**Response to Comments Submitted on**  
**Addendum No. 2 to the Everett Riverfront**  
**Redevelopment Final Environmental Impact Statement**  
**Addressing the Riverfront Development**  
**Public Amenities Master Plan**

**February 24, 2010**

Figure 2. Proposed Conceptual Restoration Actions based on goals presented in this memo.

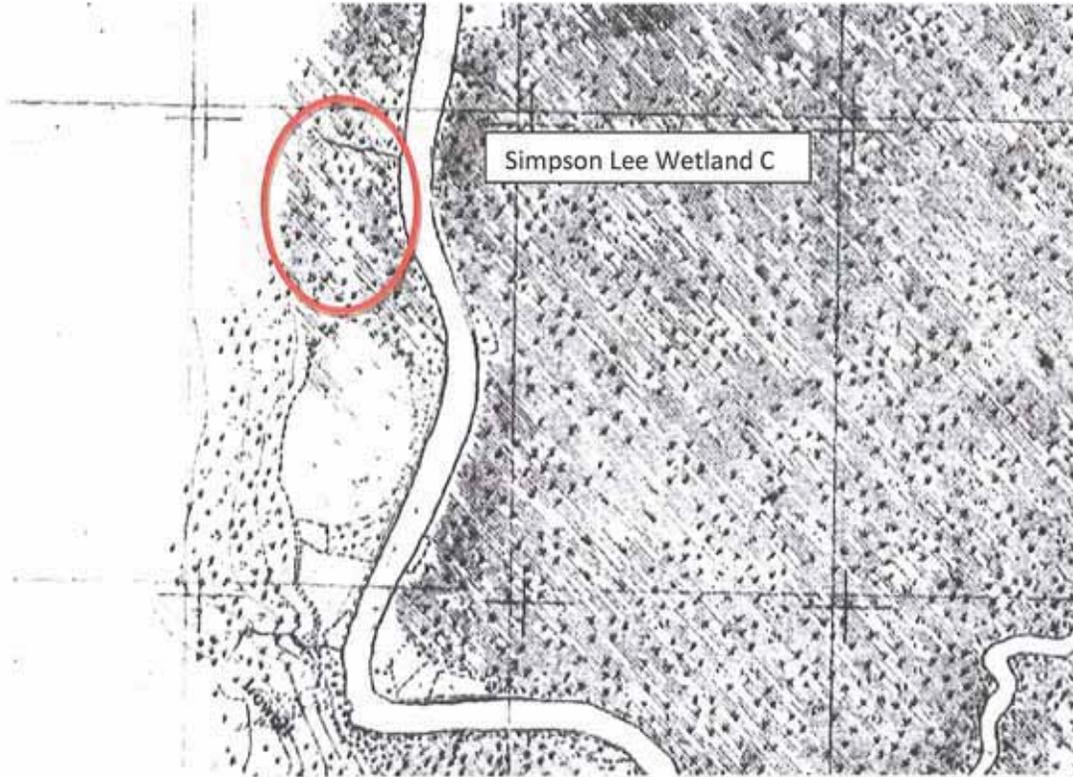
- 1) Goal 1 – Re-establish, over a 50 year period, a tidally influenced forested, scrub-shrub and emergent marsh similar to Otter Island.
- 2) Goal 2 – Increase tidal exchange within the wetland through construction of a limited number of strategically located “distributary” tidal channels. Figure 2 presents the preliminary location of these channels which should be refined through additional modeling/engineering and third party review by local experts on estuarine ecosystems. These channels are intended to distribute tidal waters throughout the wetland and not to generate sufficient tidal prism to initiate formation of dendritic tidal channels. The channels should be large enough to be self maintaining. This should include:

- b. Broaden the mouths of existing channels through the shoreline berm.
  - c. Remove old channel blocks in the main east-west channel (see Figure 2).

Figure 6. Potential restoration channels, Wetland C Simpson Lee site and calculated excavation quantities.

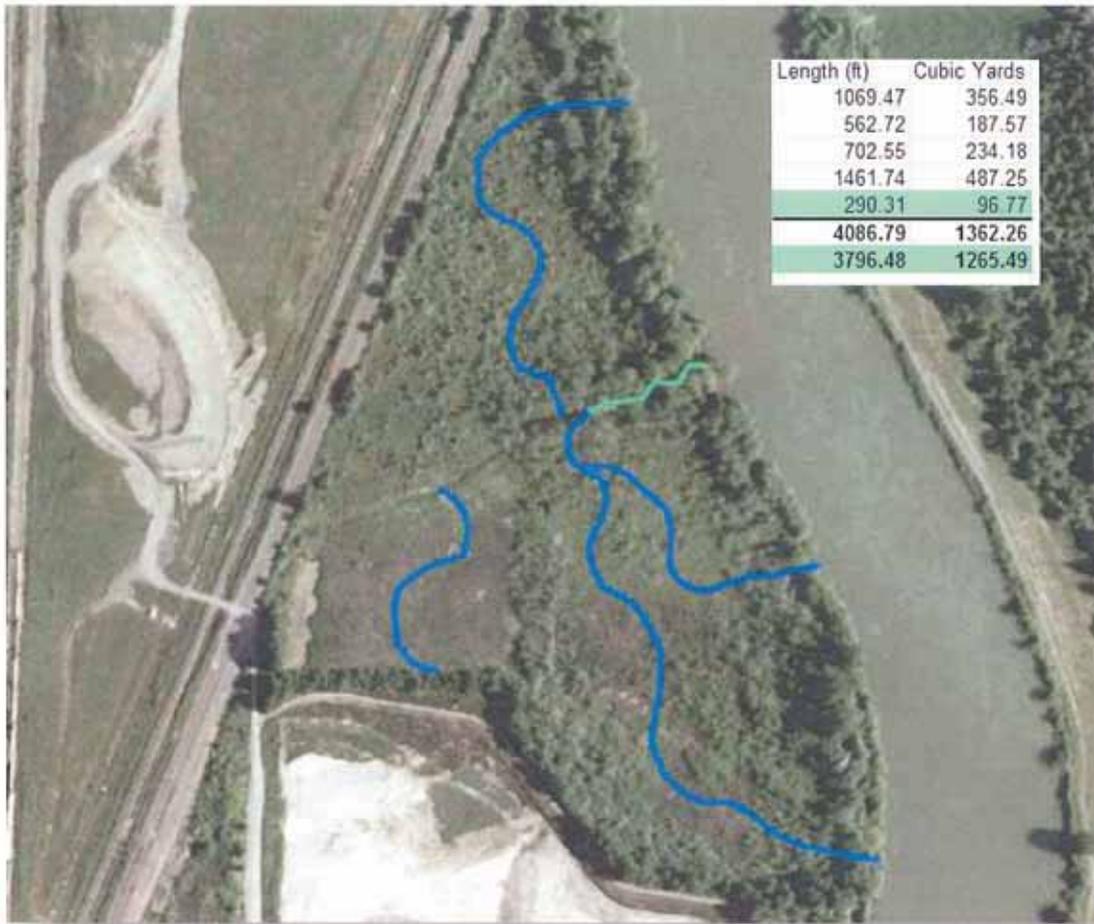
During this site visit, we observed numerous small channels that were flooded within 9" to 14" of the adjacent marsh surface. This would indicate that the marsh soils (clay loam), through capillary action, would be saturated to the surface during a tide that is less than a MHHW tide (9.17 ft NAVD88). Tidal flooding appeared to extend up the main channel to the Powerline Channel (Figures 5 and 2). In discussions with Si Simenstad, distributary channels, and not dendritic, are most commonly found in a marsh of this elevation (personal communication 9/15/08). The volume of dredging needed for small distributary channels (3' wide by 3' in depth) was estimated at 1,266 cubic yards based on the conceptual restoration design (Figure 6).

Note: The turquoise reach shown in Figure 6 and shaded rows on the table show the stream length and estimated volume of excavation for this reach. Excavation of this may not be necessary to achieve tidal circulation and the last shaded row in the table shows the stream length and volume of excavation if this reach is not included in the totals.
